TELEPHONE SETS—831- AND 2831-TYPE

IDENTIFICATION, INSTALLATION, CONNECTIONS, AND MAINTENANCE

1.001 This addendum supplements Section 503-702-101, Issue 6.

Fig. 9—31- and 2831-Type Telephone Set, Connections (Sheet 3 of 6)

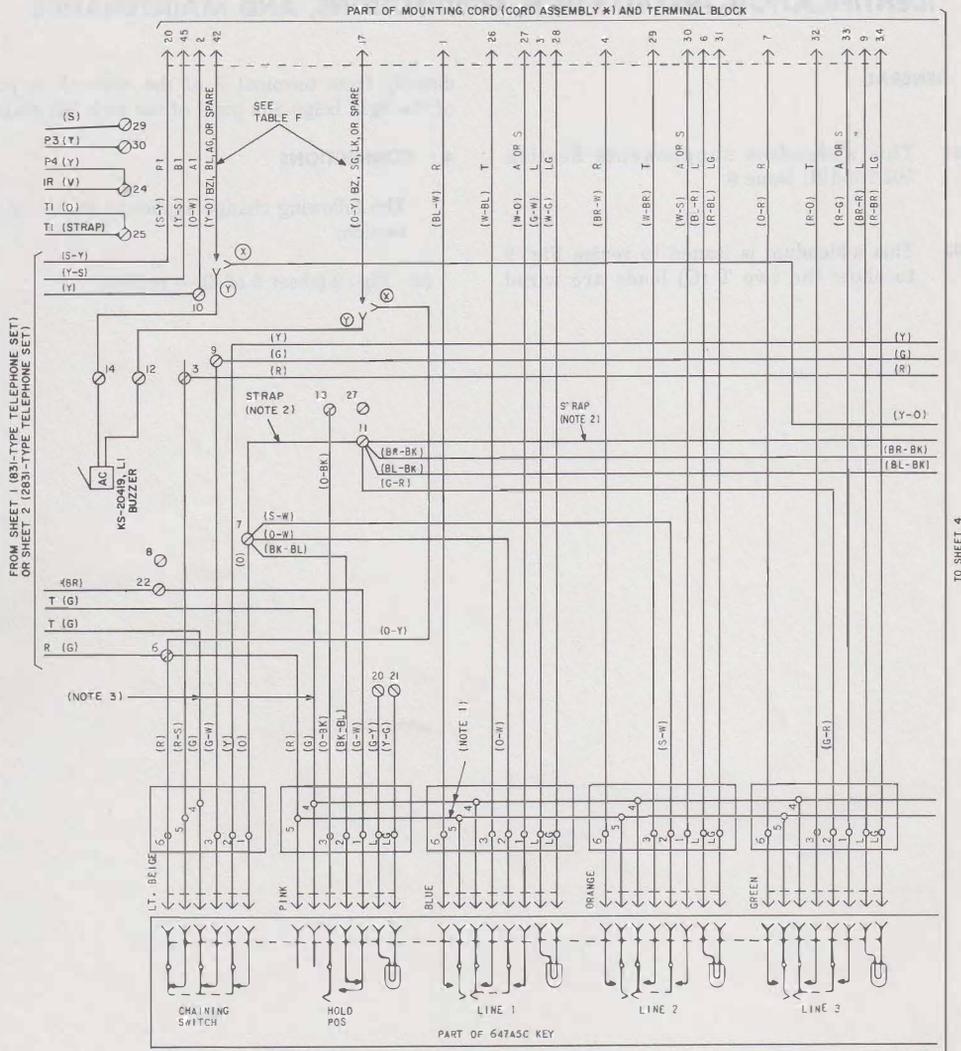
1.002 This addendum is issued to revise Fig. 9 to show the two T (G) leads are wired

directly from terminal F of the network to pin 4 of the light beige and pin 4 of the pink 508 plugs.

(a) Fig. 9 (sheet 3 of 6) — revised
